**AGENDA
TECHNICAL REVIEW COMMITTEE (TRC)
November 4, 2025
10:00AM**

A. AdventHealth Sign Variance – Alt Key 1288088

**MINUTES
TECHNICAL REVIEW COMMITTEE (TRC)
October 7, 2025
10:00AM**

SIGN PACKAGE

ST.J FLUSH MOUNT, FACE LIT "ER" CHANNEL LETTER DISPLAY

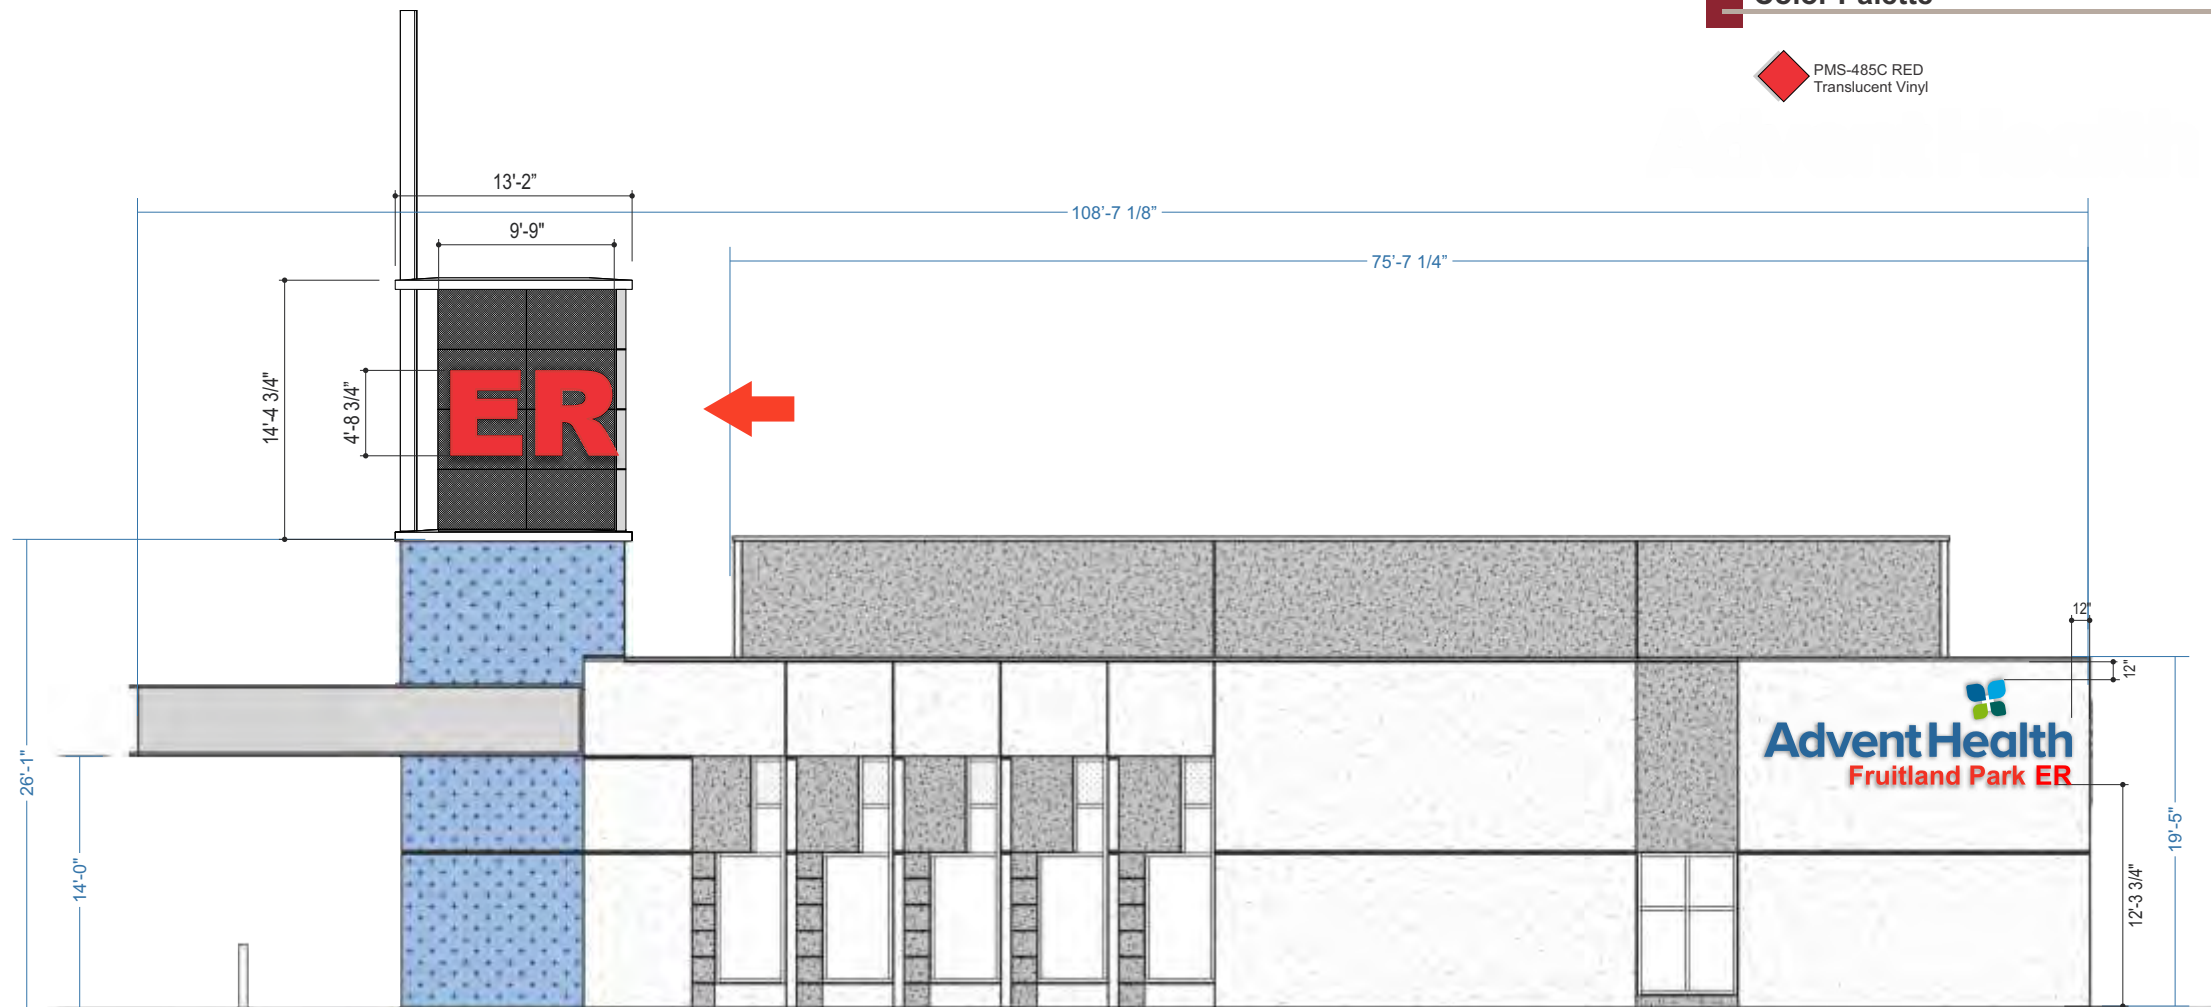
During committee discussion, the City Manager raised concerns that unlike other AdventHealth sites, this facility is adjacent to residential properties rather than in a commercial area. The variance application was also found to be incorrectly labeled as a "west-facing" request when it actually applies to a "south-facing" sign, which directly faces nearby residences. The City Manager expressed concern regarding potential light intrusion from the illuminated red signage into residential yards.

It was determined the City needs updated documentation that accurately portrays the direction of the signage and would return for the November TRC Meeting and tentatively be presented to the Planning and Zoning Board in November, followed by review by the City Commission in December.

The spire is oriented such that it faces South/North rather than East/West. Because of the turn on CR 466A, the ER sign is harder to see. Illuminating it would make the building much easier to find. We're requesting approval to internally illuminate the south-facing ER portion of the spire/architectural feature. I've included a few screen shots from the construction drawings to provide a visual of the ER orientation on the building.

This makes the statement in the resolution about the ER lettering on the beacon sign facing westward invalid; we are requesting that the ER lettering be illuminated facing **south**.
